**ST. LUCIE PLANT
UNIT 1 AND UNIT 2**

**IMPROVED TECHNICAL
SPECIFICATIONS CONVERSION**

**ITS SECTION 3.1
REACTIVITY CONTROL SYSTEMS**

**Current Technical Specifications (CTS) Markup
and Discussion of Changes (DOCs)**

Figure 3.1.3-1 (page 1 of 1)
Allowable Positive MTC Limit

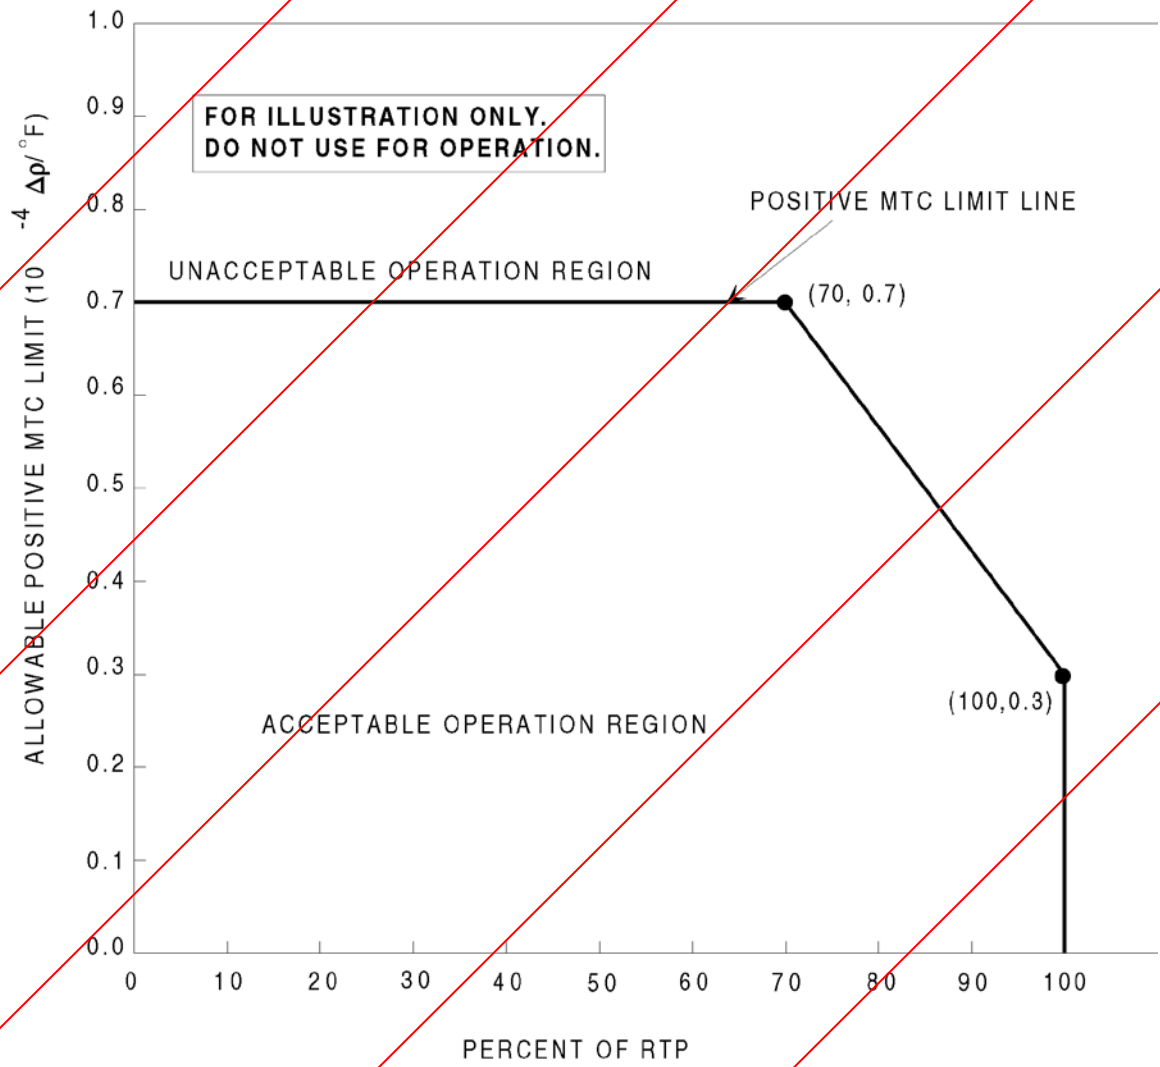
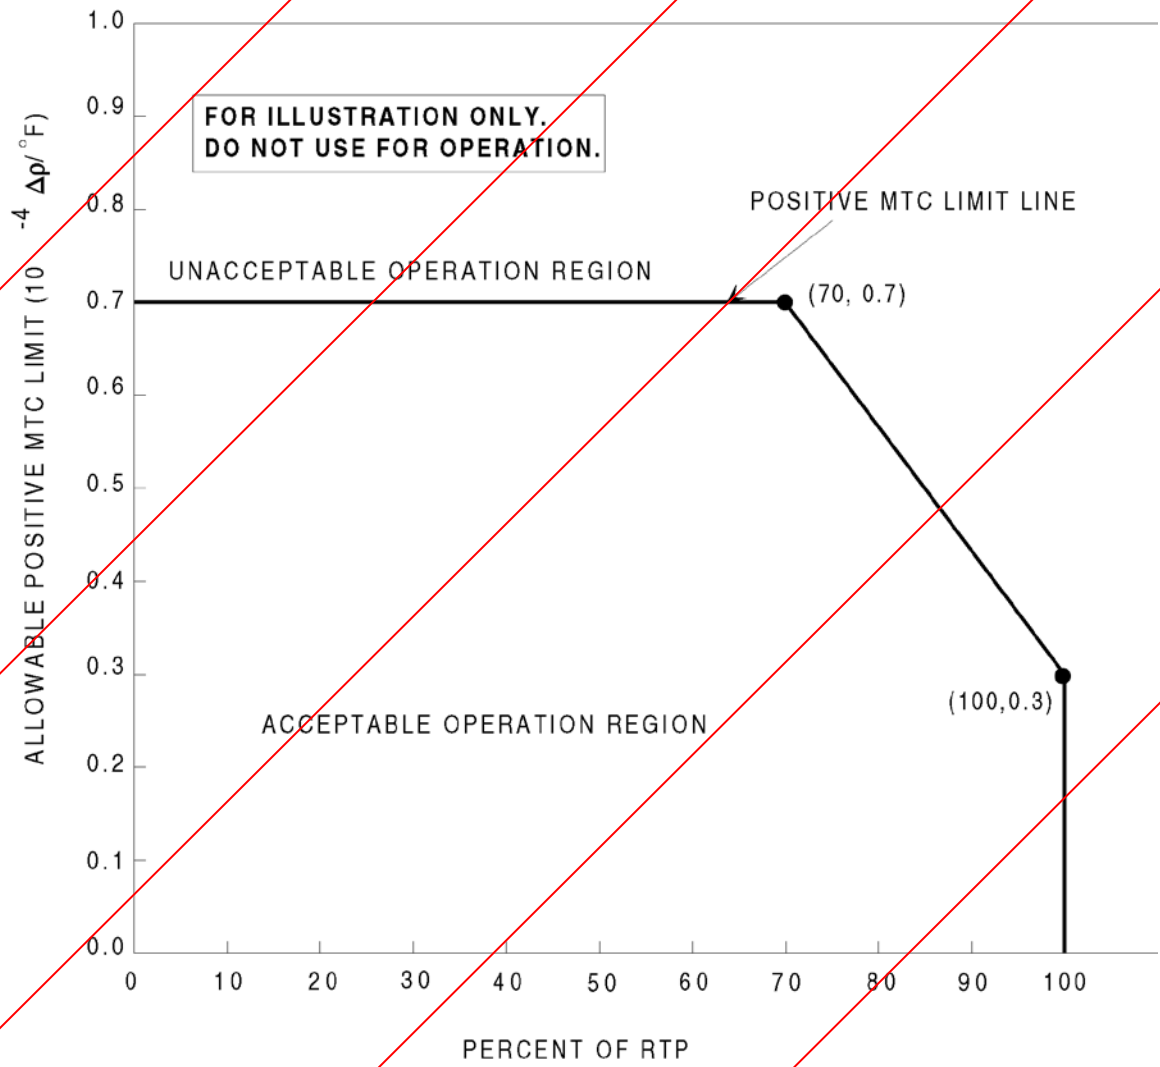
2. ISTS 3.1.3 contains Figure 3.1.3-1 for Allowable Positive MTC Vs Percent of RTP. This figure is not maintained in ITS 3.1.3. ITS 3.1.3 lists the maximum upper limit value based on THERMAL POWER level in the LCO. Therefore, ISTS Figure 3.1.3-1 is not required and has been deleted.

The MTC shall be maintained within the limits specified in the COLR. The maximum positive limit shall be: ~~that specified in Figure 3.1.3-1.~~

FIGURE 3.1-1 ST. LUCIE 1 MIN BAMT VOLUME VS STORED BAMT CONCENTRATION (MODES 1, 2, 3 and 4)

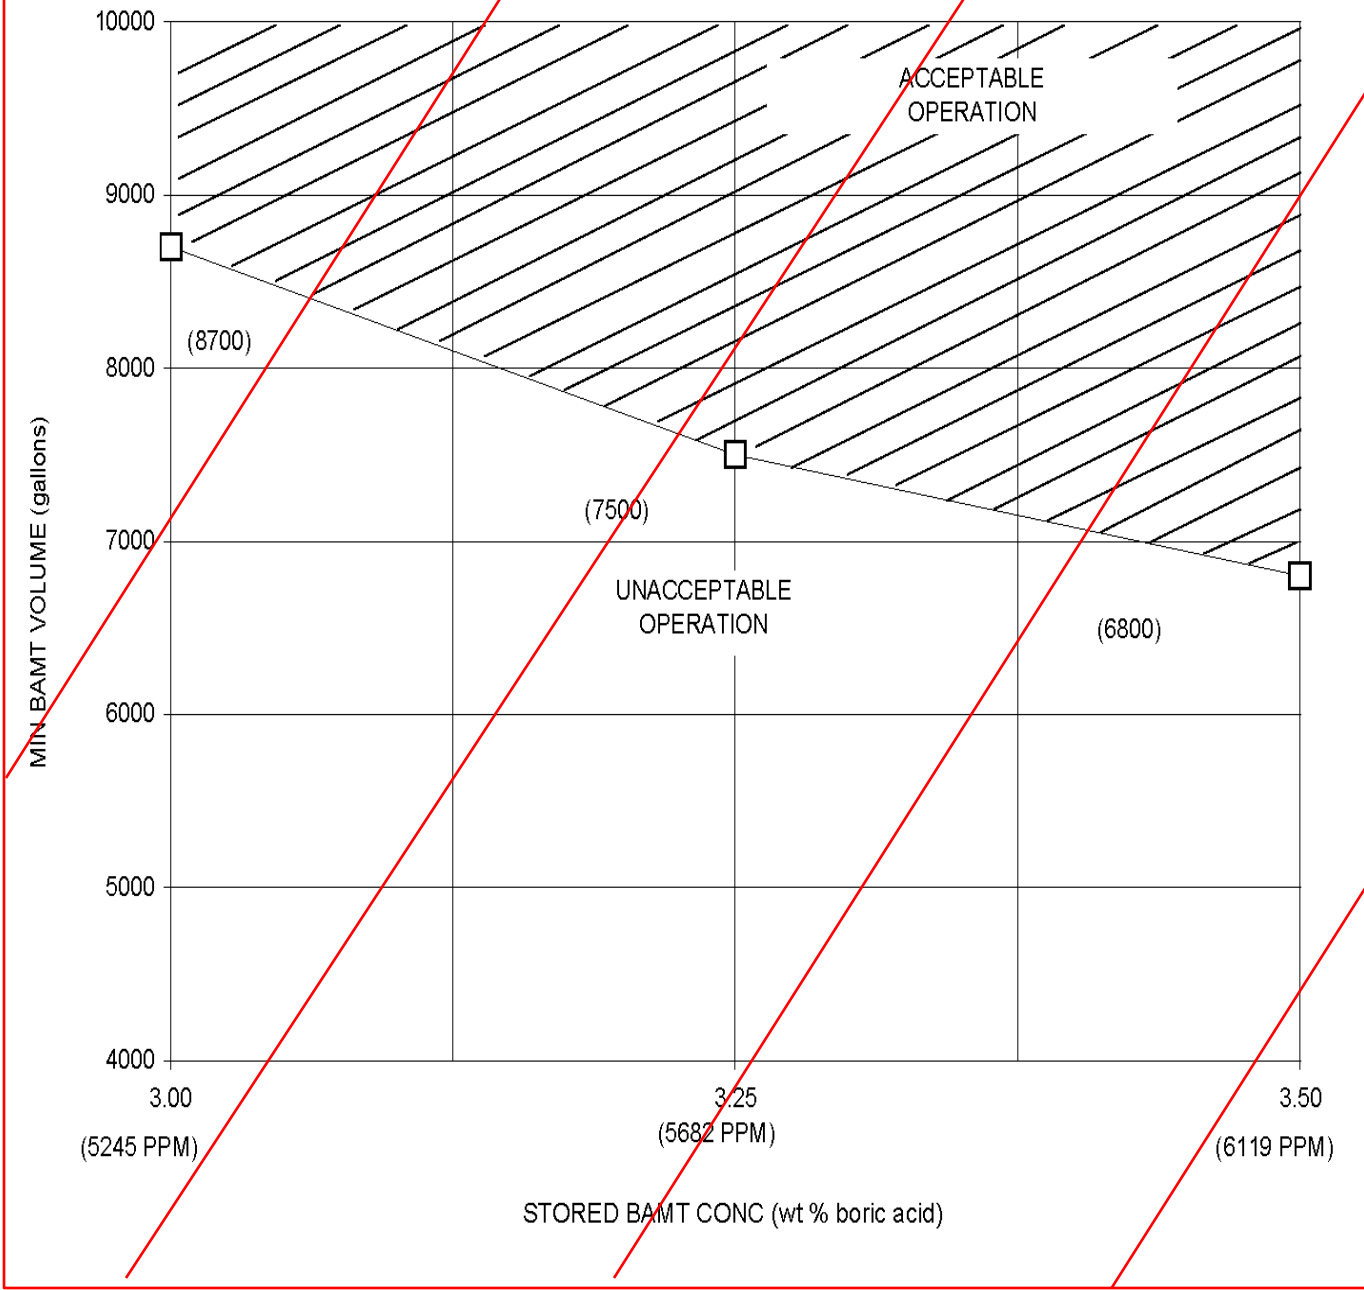
R01
